RIVERS PHASE II

Final Environmental Impact Report

SCH 2005042018

April 2006

FIGURE 3-3
Vesting Tentative Subdivision Map

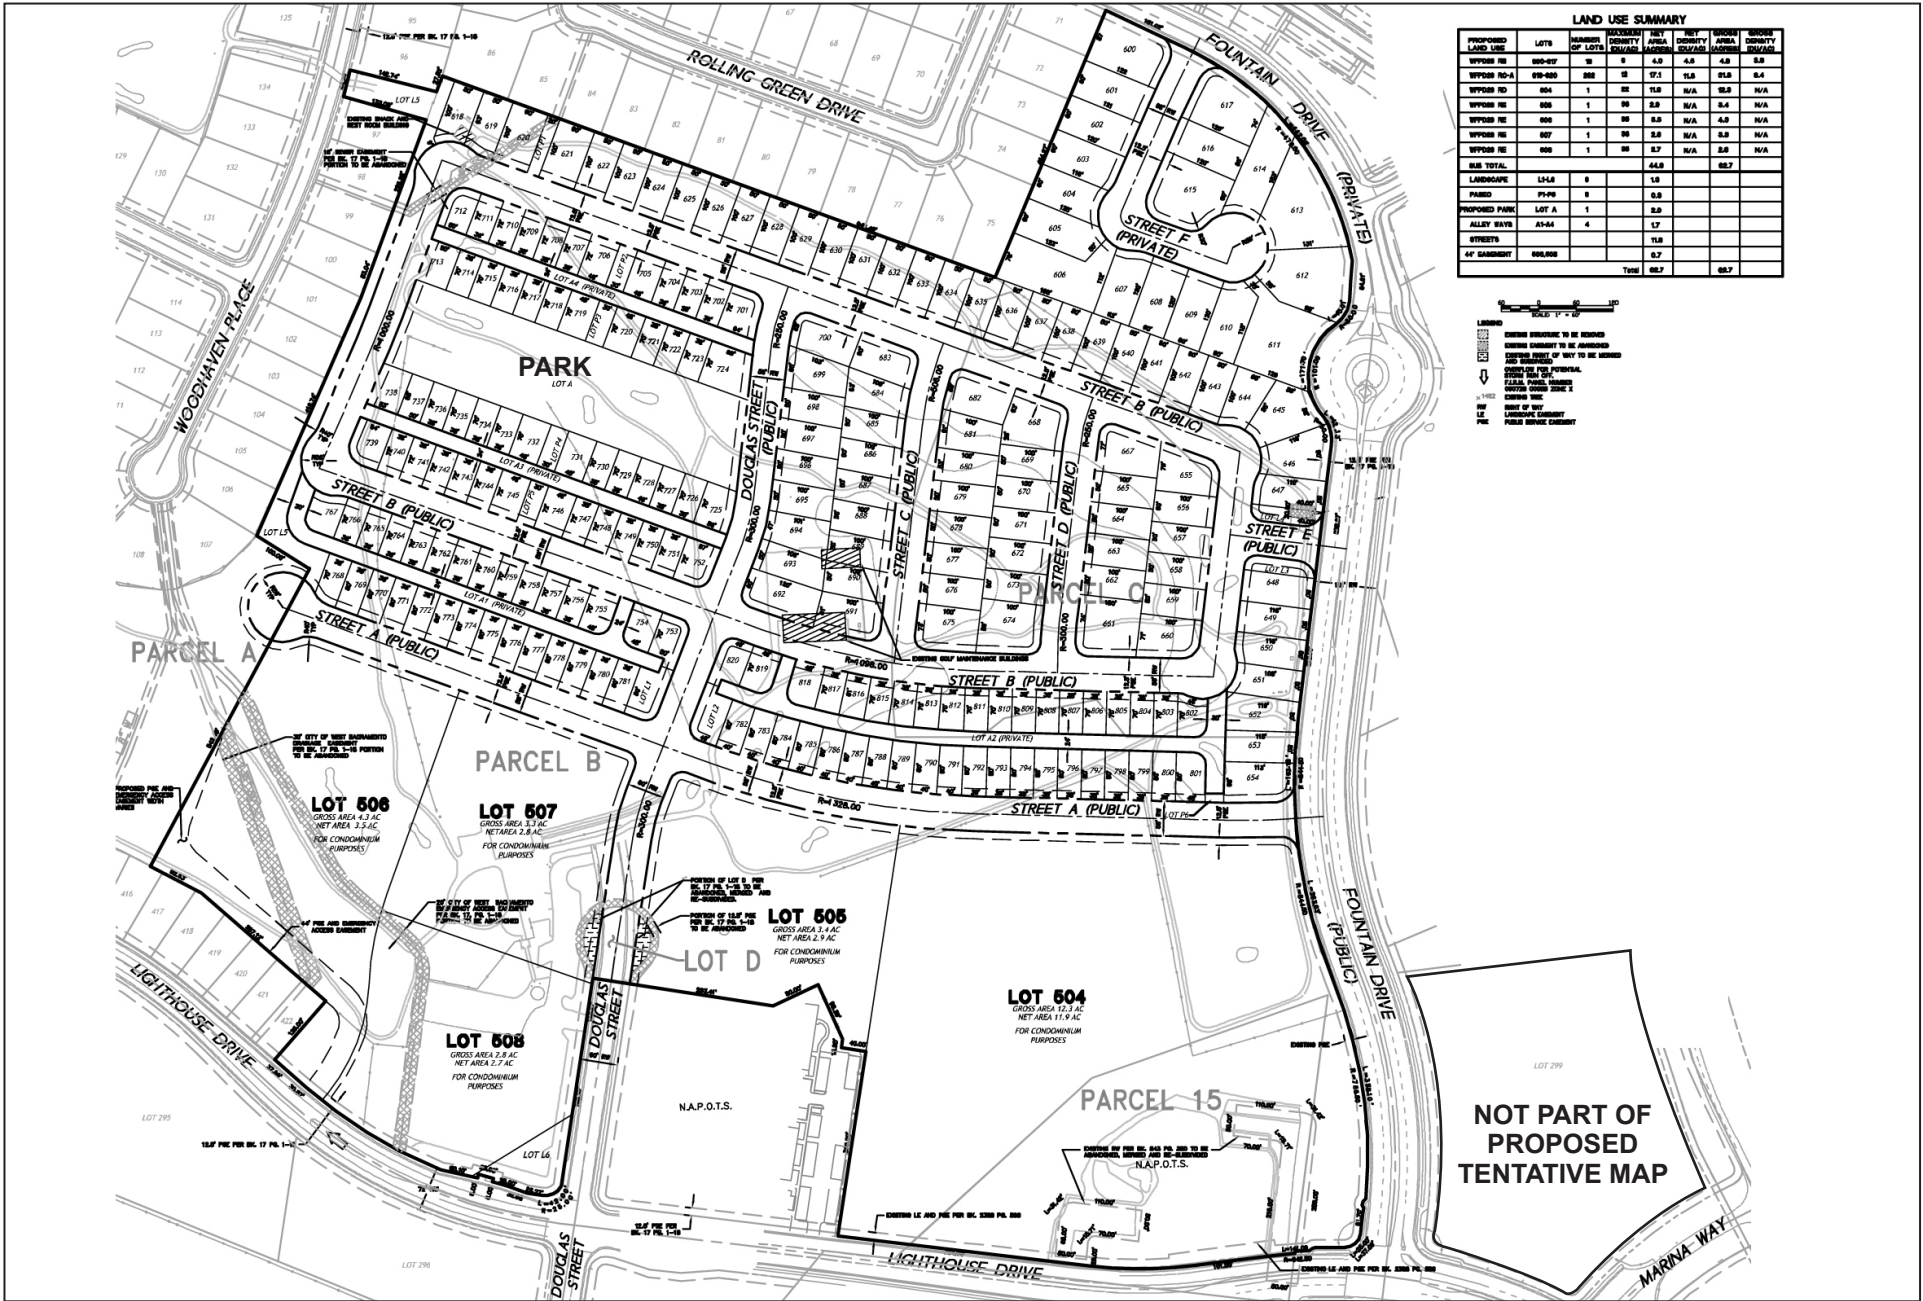
Figure 3-3, Vesting Tentative Subdivision Map, on page 3-7 of the Draft EIR is revised to note that the lots designated RD and RE single-family attached units would be developed as condominiums. This does not change the conclusions of the Draft EIR. The revised figure is included at the end of this chapter.

FIGURE 3-8A
Hiking Trail Conceptual Plan

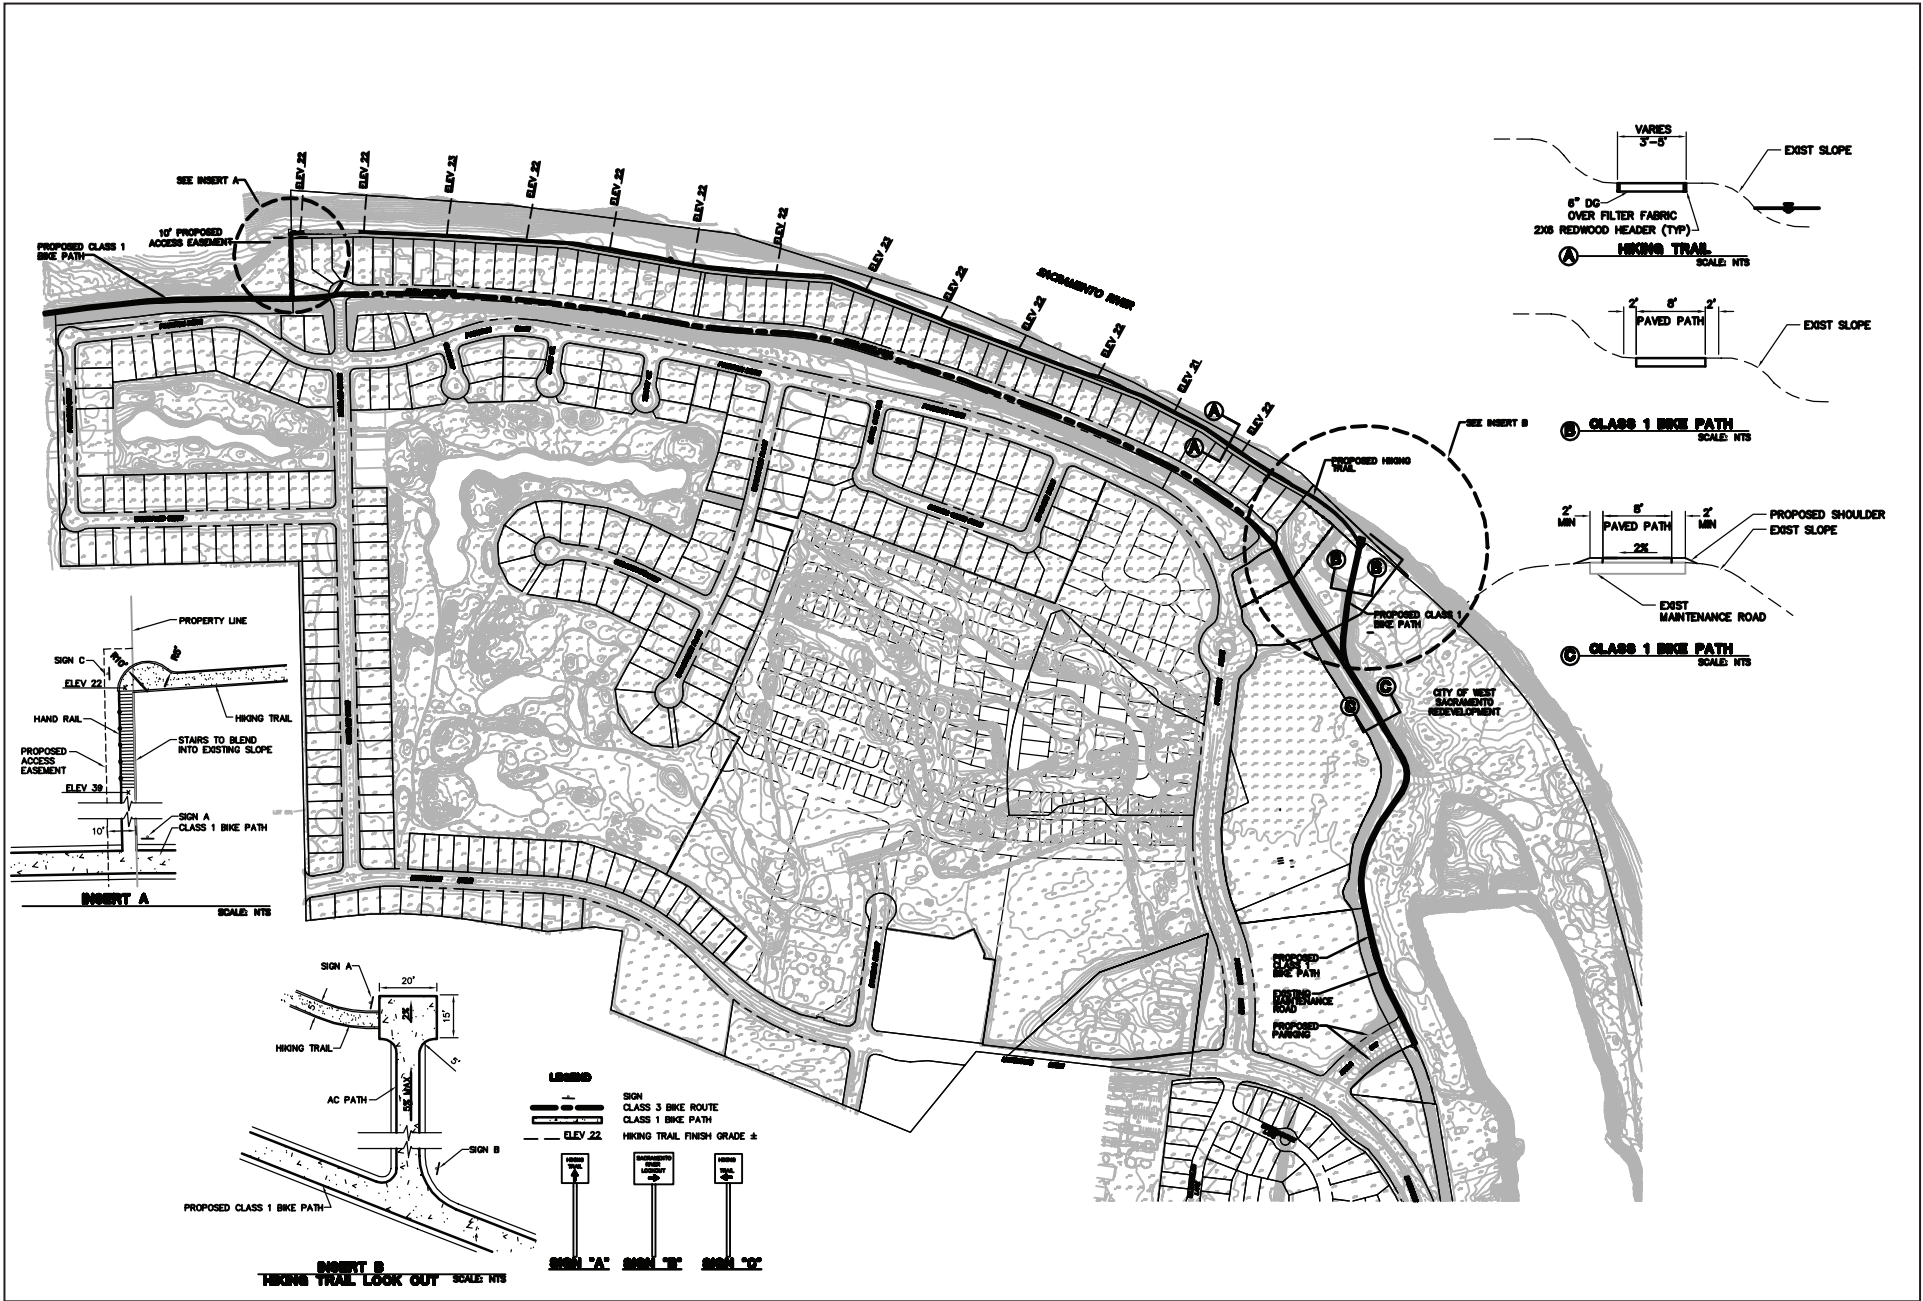
Figure 3-8, MBK Levee Typical Cross Section, on page 3-16 of the Draft EIR has been revised to include the proposed informal hiking trail and is included at the end of this chapter. In addition, the figure numbers are revised and the new figure numbers are 3-8a and 3-8b.

FIGURE 3-8B
MBK Levee Typical Cross Section

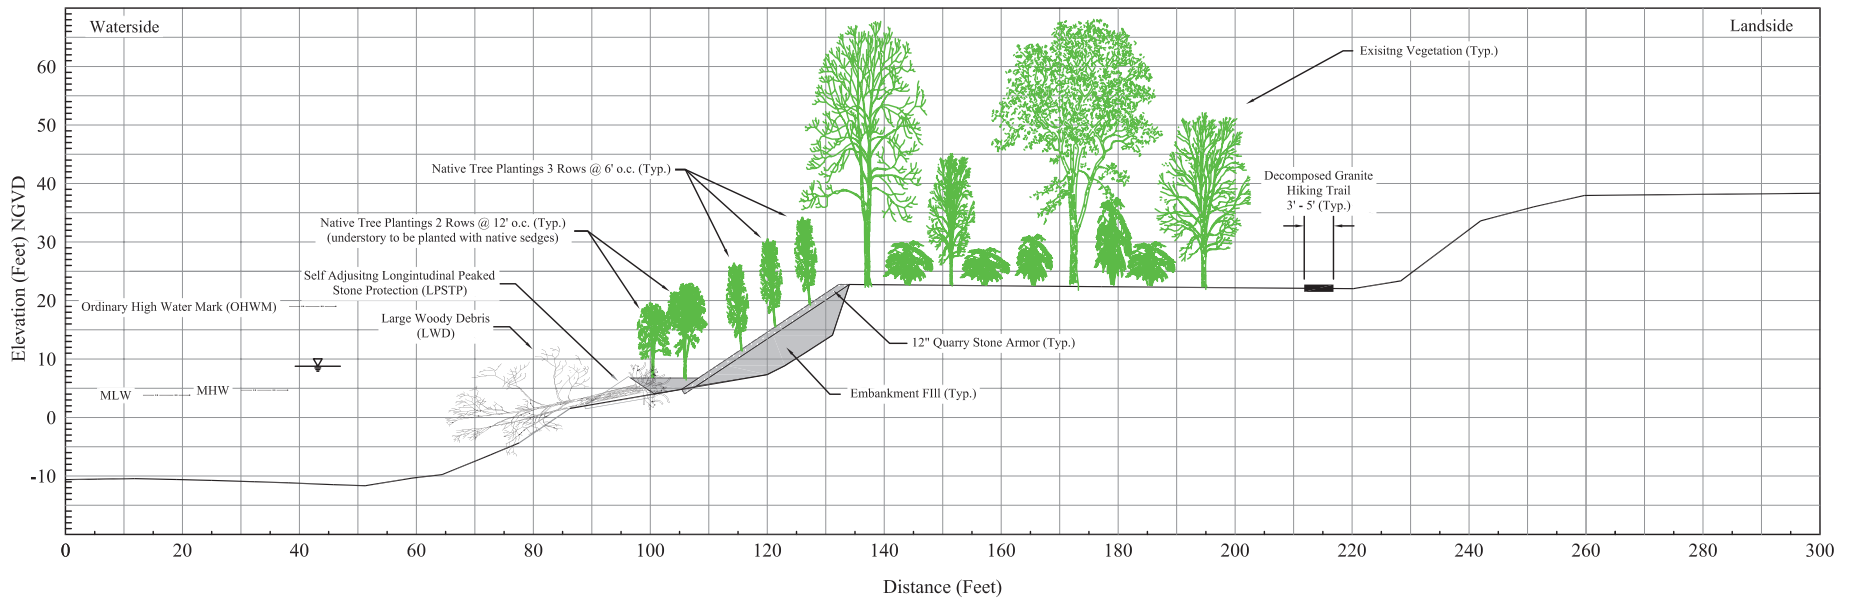
Figure 3-8, MBK Levee Typical Cross Section, on page 3-16 of the Draft EIR has been revised to include the proposed informal hiking trail and is included in Chapter 2 of this Final EIR. In addition, the figure number is revised and the new figure number is 3-8b.

FIGURE 4.6-1
 Existing PD-29 Designations

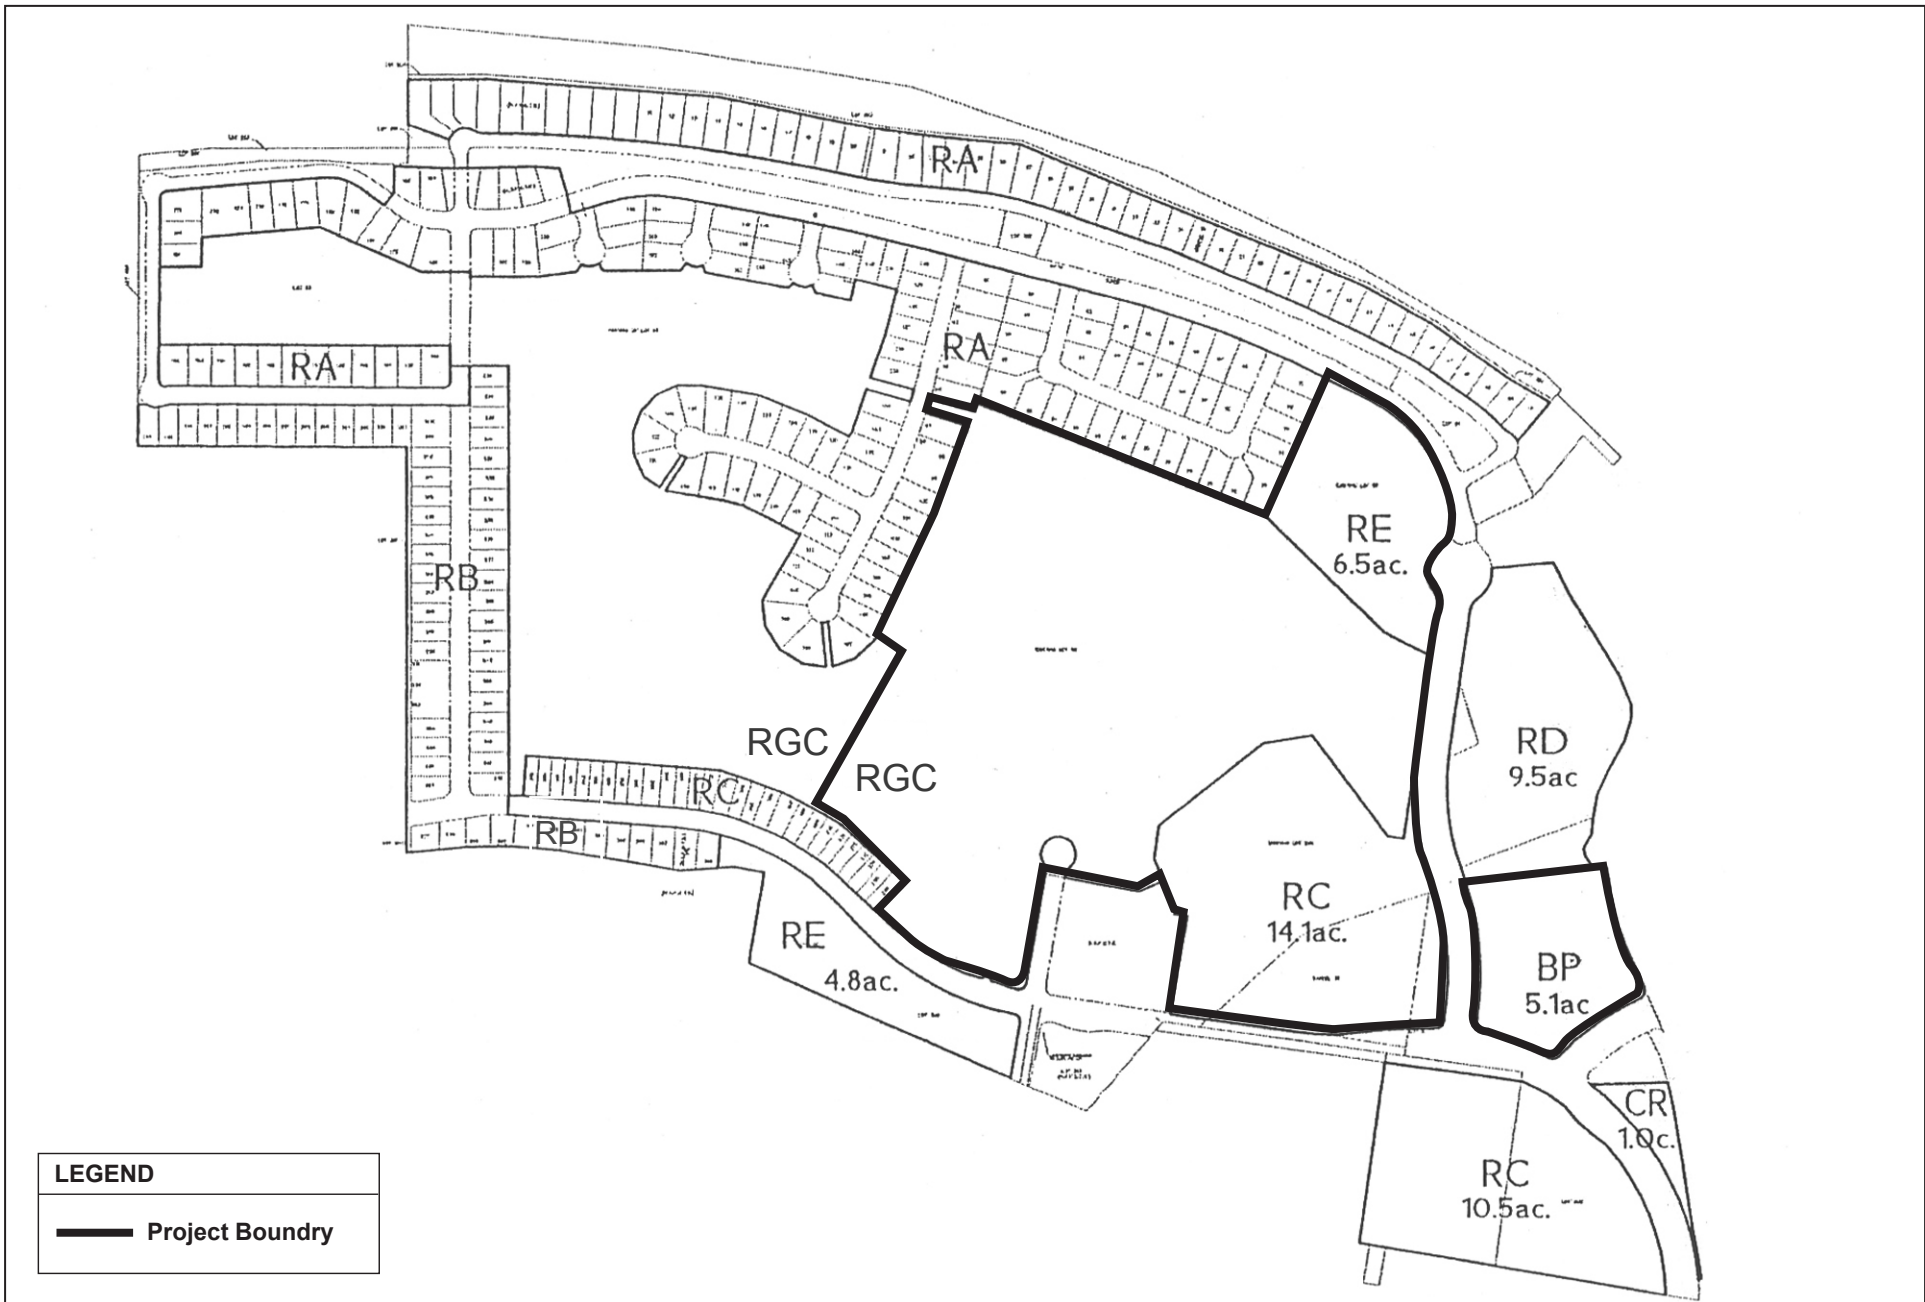
Figure 4.6-1, Existing PD-29 Designations, is revised to show the RB designation in the southeast portion of the site. Additionally, the BP/CR designation is changed to BP. The revised figure is included at the end of this chapter.
